Permit Number: 080826

has permission to Recover (1) awning with sign (3'x6'3") & install two building signs (8"x88" each)

AT 511 CONGRESS ST

**City of Portland, Maine - Building or Use Permit Application**

Date: 6/20/08	Scale:
Drawing #: 1	Sales Rep: AE
Rev #: 1	Rev Date: 6/26/08

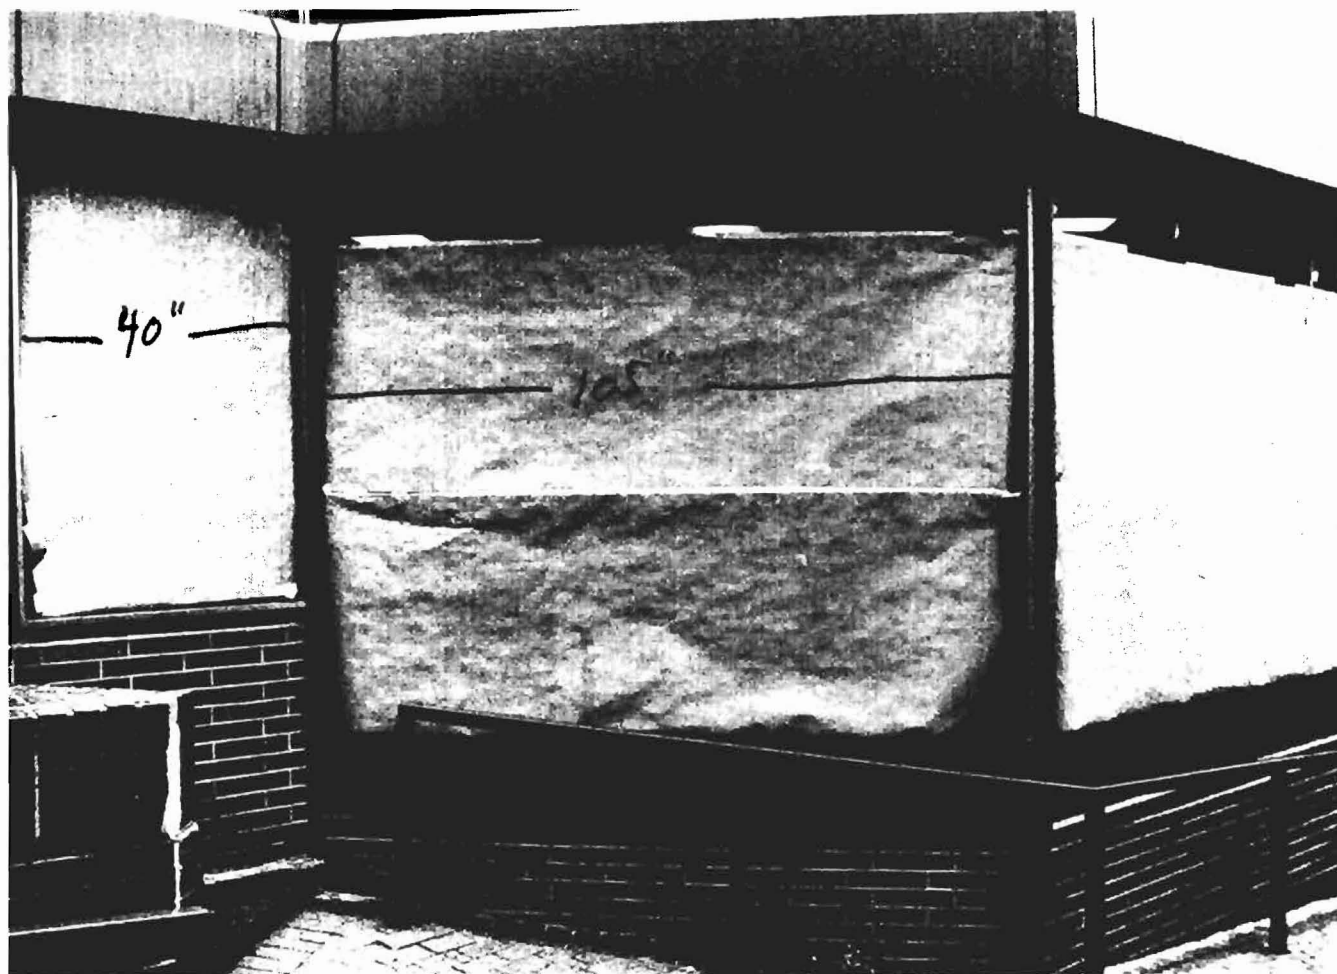
1) \*Awning material must be opaque (application calls for translucent fabric), so as not to emit light. (Only graphics on awning face may emit light.) Color of awning must match surrounding sign panel.

This is not a permit; you may not commence ANY work until the permit is issued.  
awning is translucent 36" x 75.75" = 18.94 s.f.  
old awning was 19.53 s.f.

old awning 3'2" x 6'2" OK

\* Per 8/4/08 discussion with David of Sign Concepts, proposed awning material will back-painted (except for lettering and illustration on front panel) so that it will not be translucent.

Date: 6/20/08	Scale:
Drawing #: 2	Sales Rep: AE
Rev #: 1	Rev Date: 6/26/08

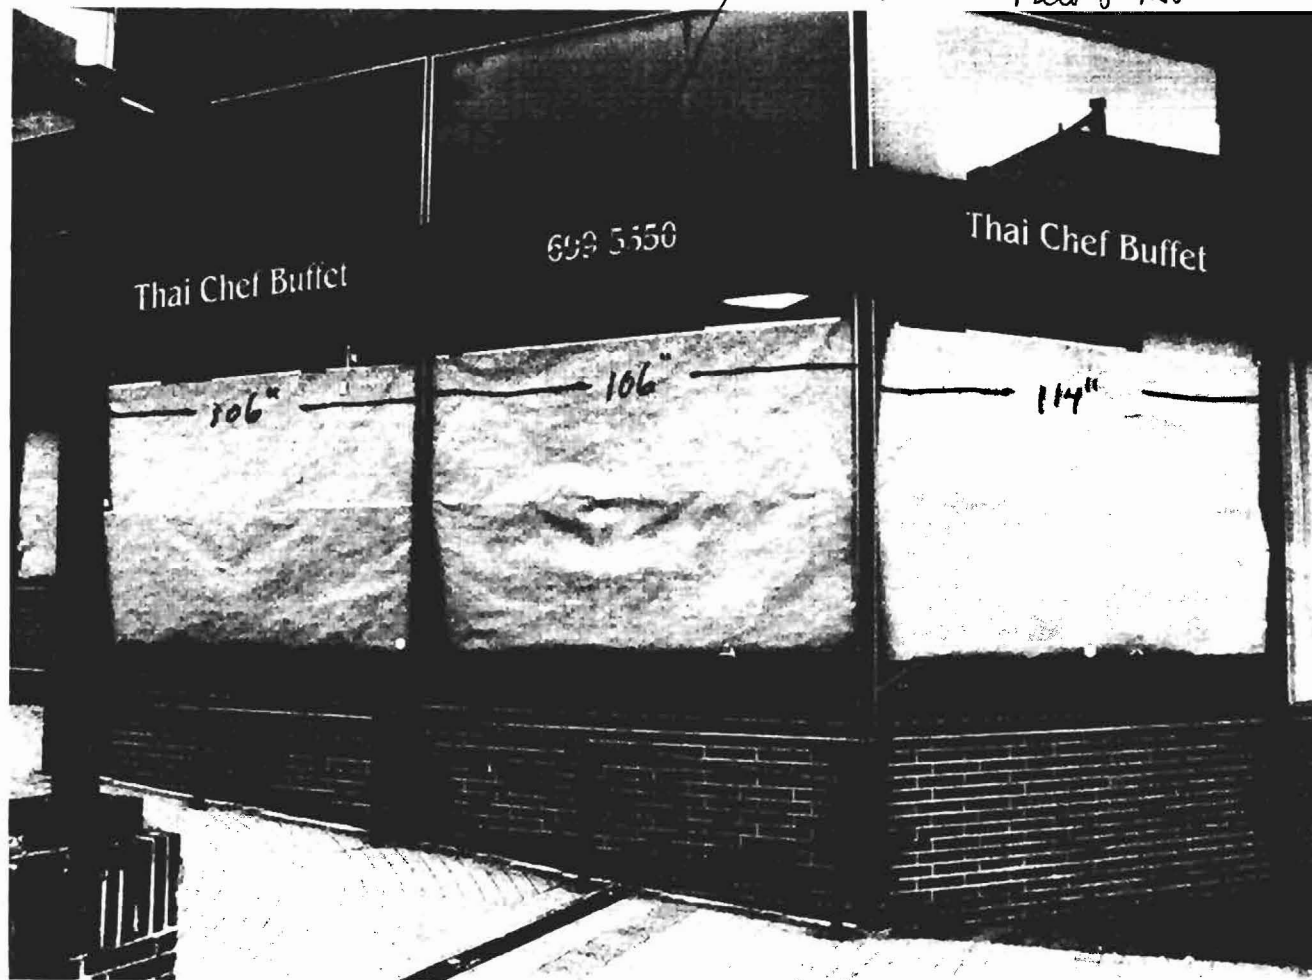
**Note:** Ordinance only allows one building sign per tenant but these signs are legally nonconforming (permit #94-1099). The awning sign remains the same. The two building signs are smaller than the originals. **Ok to Issue:**

new  
8" x 88"

(old D'Angelo's)  
10'7" x 1'3/4"

not doing  
landlord  
retreat  
it

(old D'Angelo's)  
9'6" x 1'3/4"  
new 8" x 88"

$$8" \times 88" = 704\text{ft} = 4.89\text{ft} \times 2 = 9.78\text{ft}$$

new signs smaller than D'Angelo's  
more conforming.
